RECALL CAMPAIGN

NHTSA# 17V-590

2016-2017 Greyhawk 29ME Class C motorhomes
2016 G1ME0051-0236
2017 H1ME0051-0260

FIG 9: Push any excess LP hose up through the floor. Hose should remain taut from the LP manifold to where it goes up into the floor on driver side of the unit.

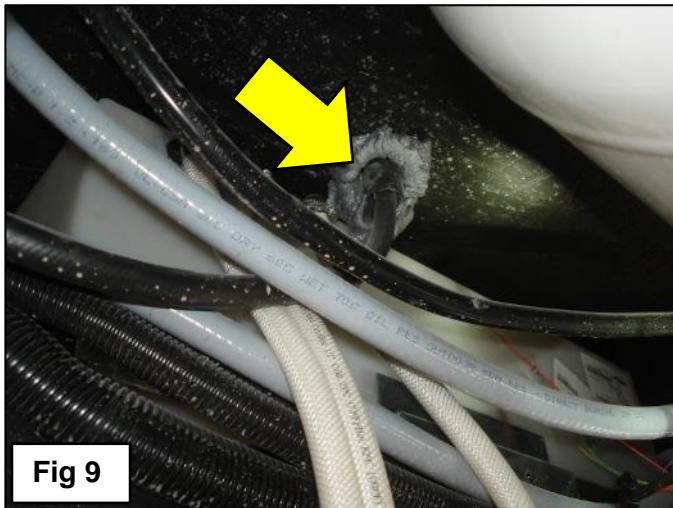
FIG 7 & 8: Gas hose should be secured to the floor with at least 1 P-clamp in center of vehicle between frame rails. Install additional P-clamps as needed to provide sufficient clearance. The LP hose should be taut to frame without restricting flow of LP.

FIG 10: Remove the damaged hose from the manifold block with the 9/16" open end wrench. Remove the damaged hose from the stove connection with a 3/4" open end wrench.

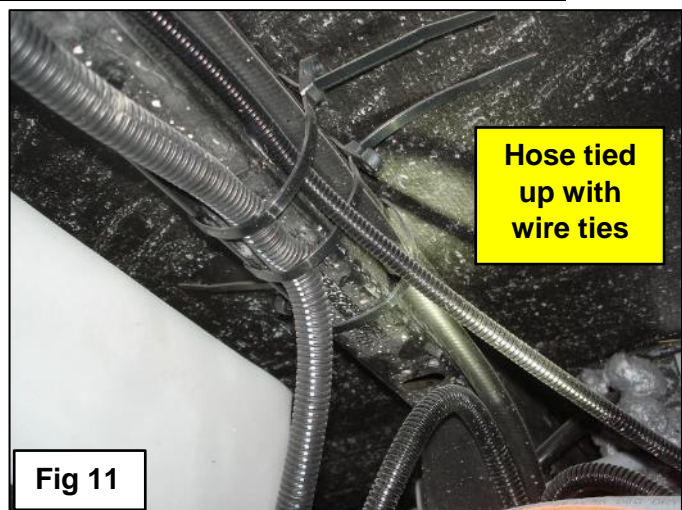
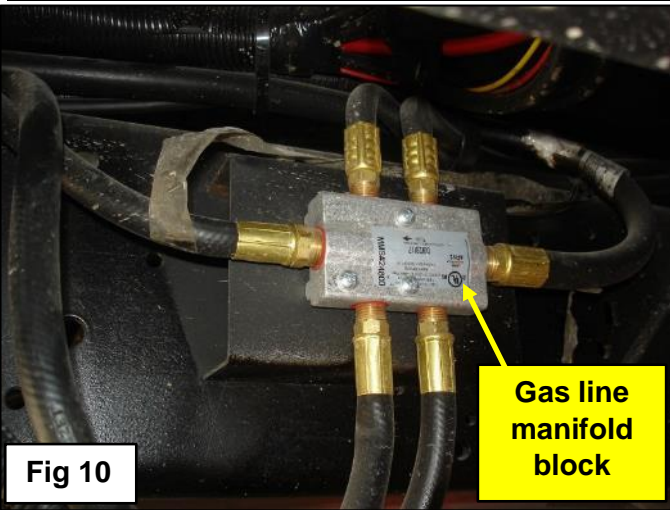
B: Replace LP hose if worn, burnt, and/or scuffed in anyway : Parts Kit 17V-590B

Replace all P-clamps in the original locations to hold the new hose in place. Hose should be taut so it is not hanging or dangling, without restricting the flow of LP. Secure the LP hose to the manifold block, and to the stove above the floor. Inspect LP hose to ensure there are no restrictions to gas flow.
